# CITY OF ALBUQUERQUE

**Re: Lot 7 Block 8 SAD 227  
Volcano Cliffs Subdivision Unit 5  
6201 Keyenta Dr. NW  
Grading and Drainage Plan  
Engineers Stamp Date 1/25/2019 (E10D051)  
Pad Certification Date 3/4/2020  
CO Certification Dated: 9/21/2021**

## DRAINAGE AND TRANSPORTATION INFORMATION SHEET (REV 6/2018)

ENGINEER'S SEAL	6201 KENYENTA	DRAWN BY WCVJ
	GRADING AND DRAINAGE PLAN	DATE 1-25-19
		218144-LAYOUT-10-02-18
1/25/19		SHEET #
DAVID SOULE P.E. #14522		JOB # 218144

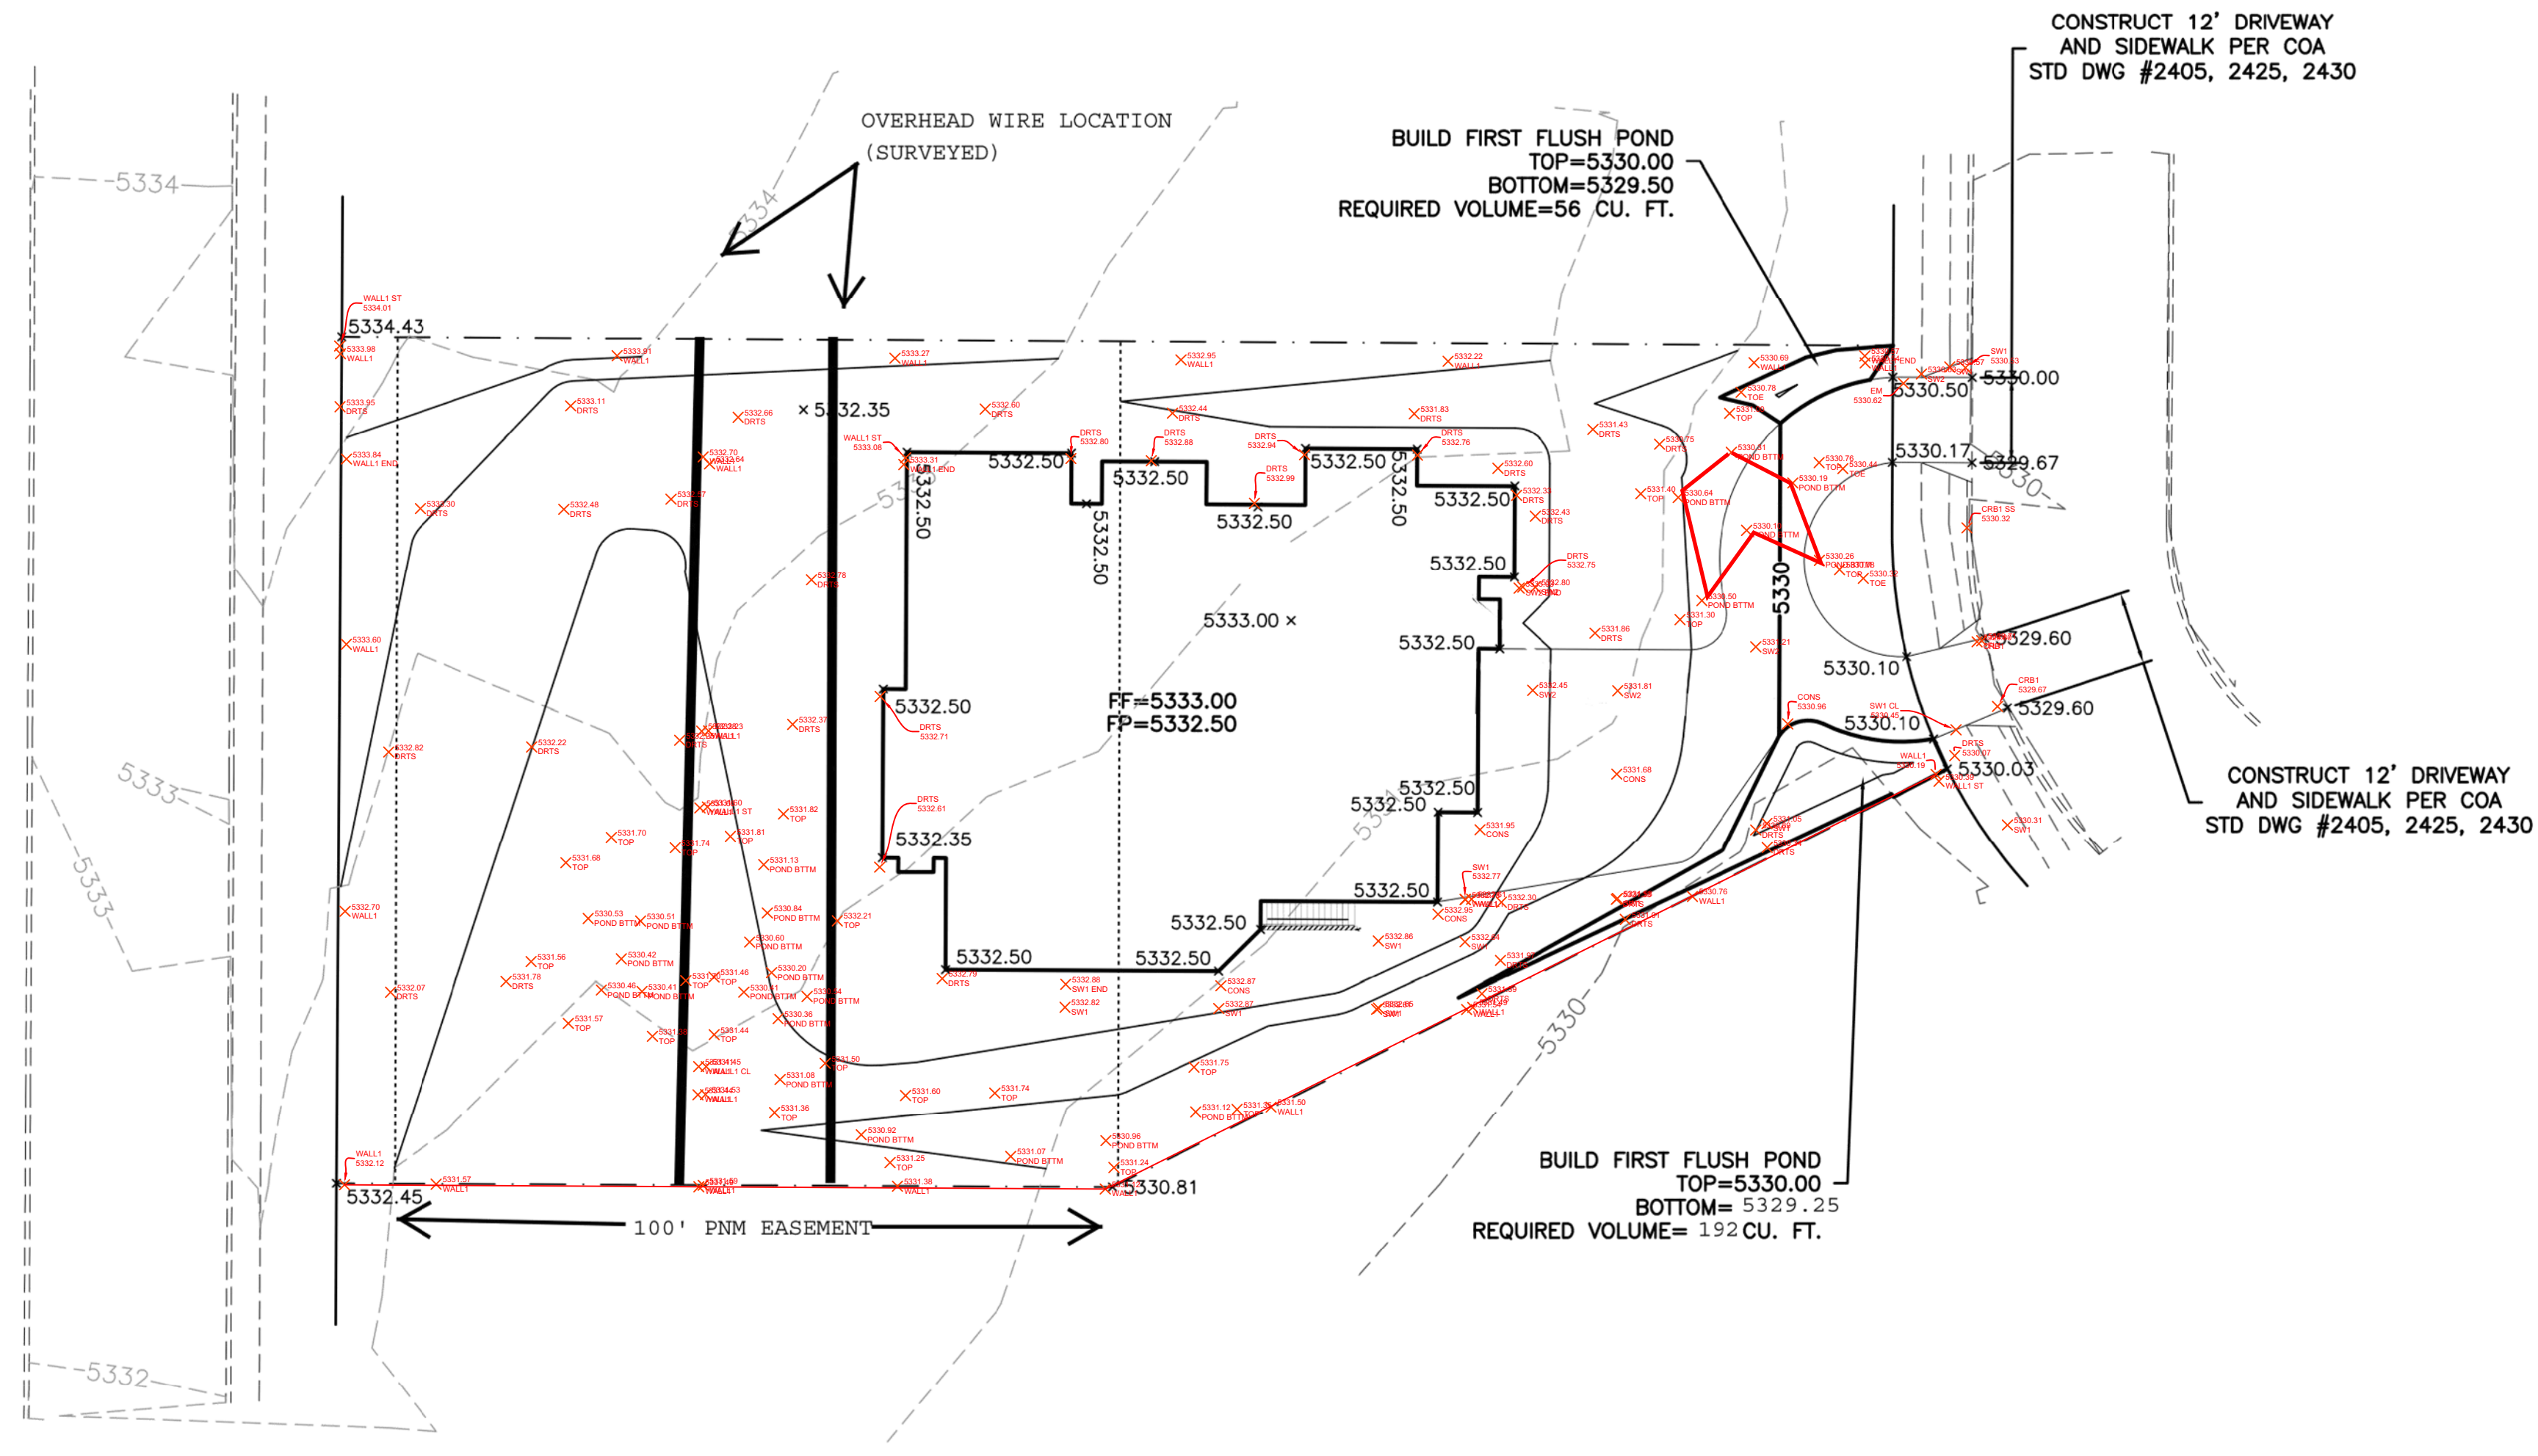
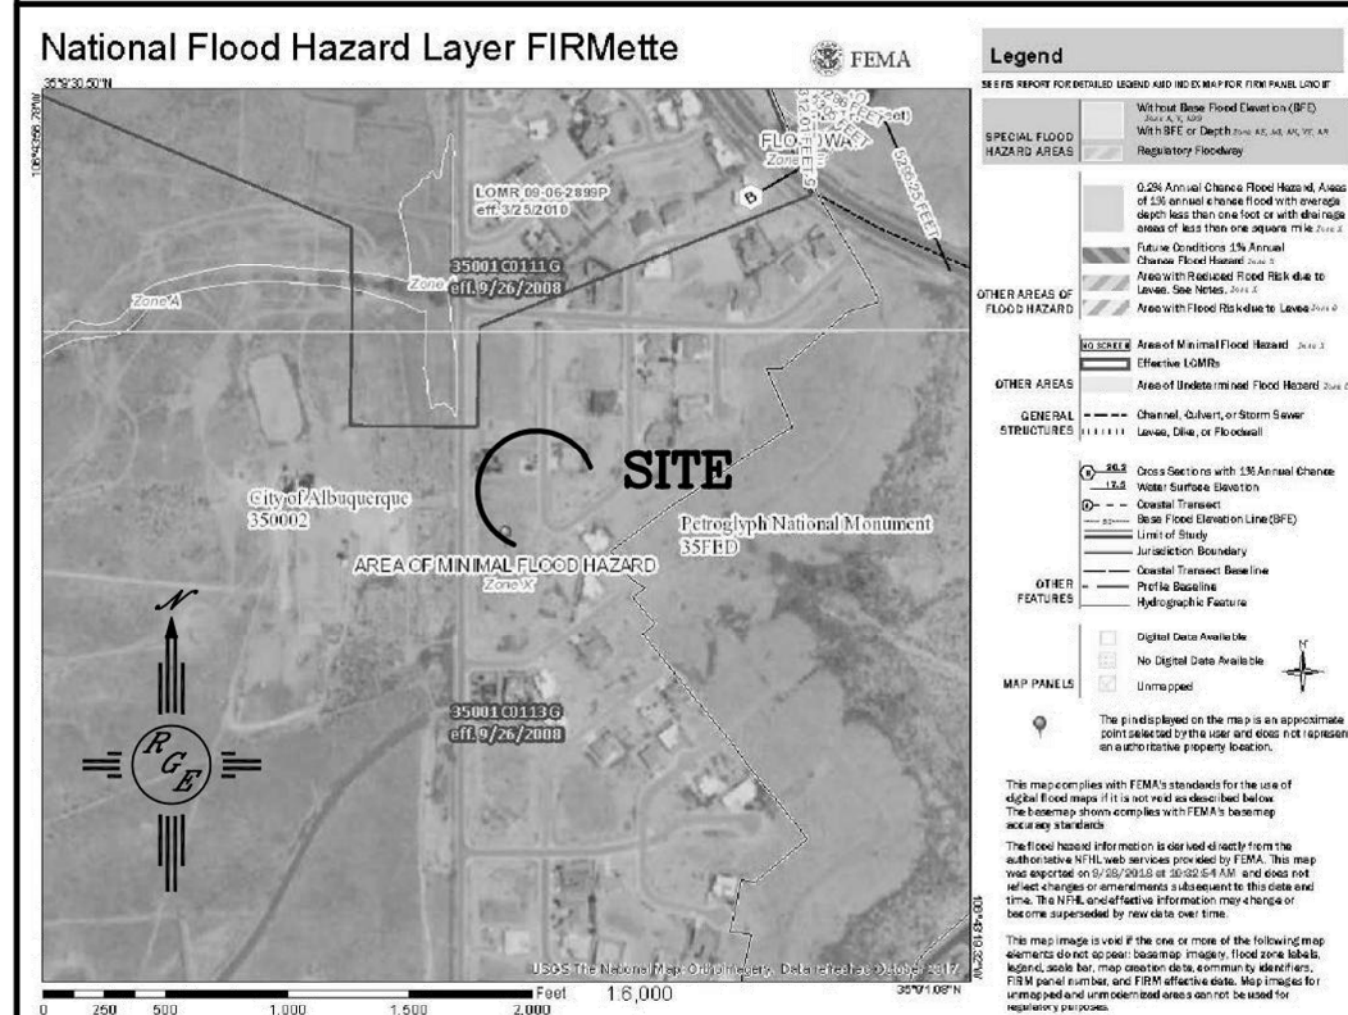
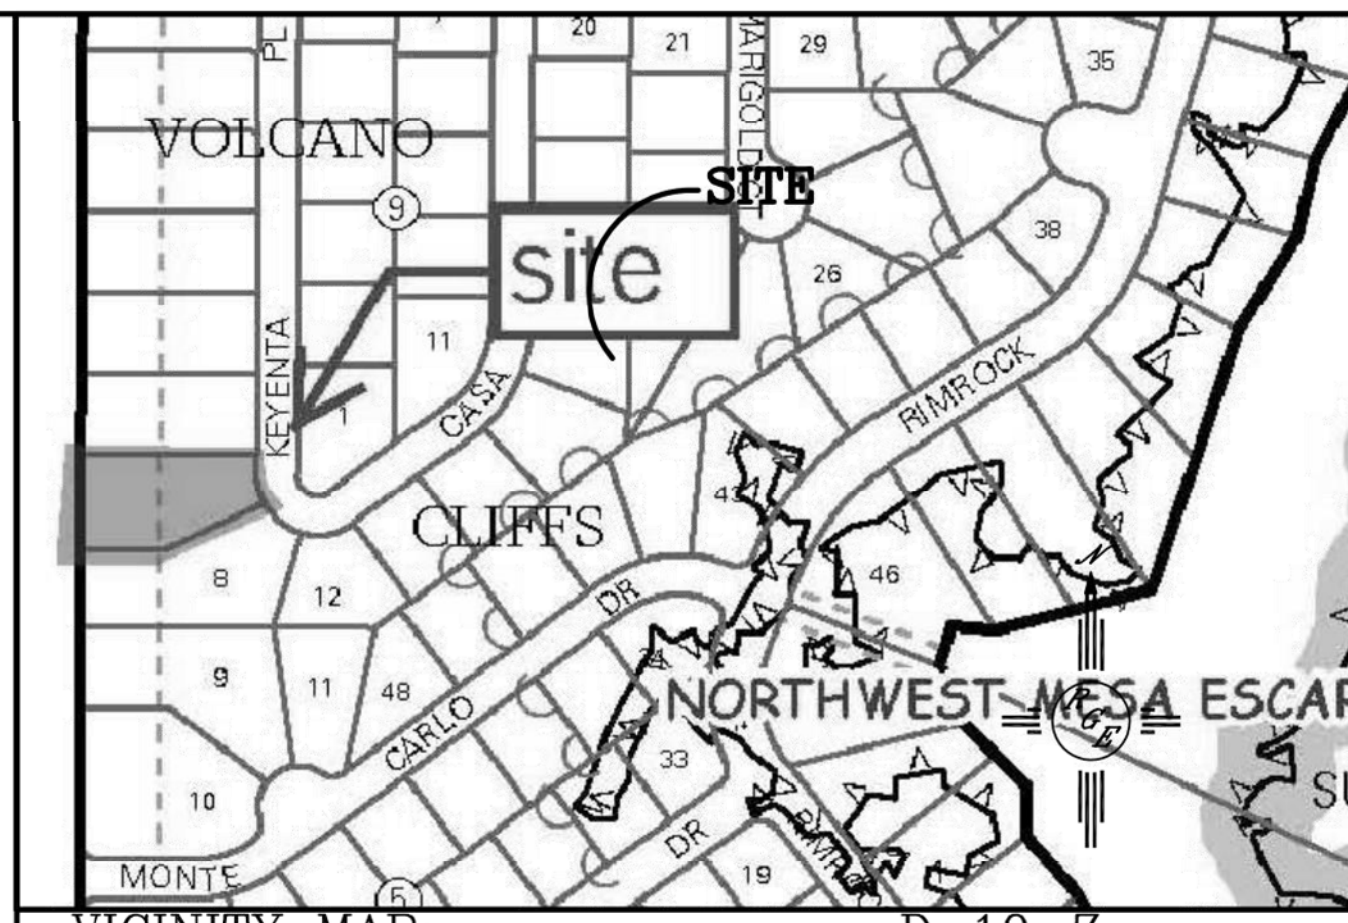
Based on the Certification received on 9/24/2021, the site is acceptable for release of Certificate of Occupancy by Hydrology.
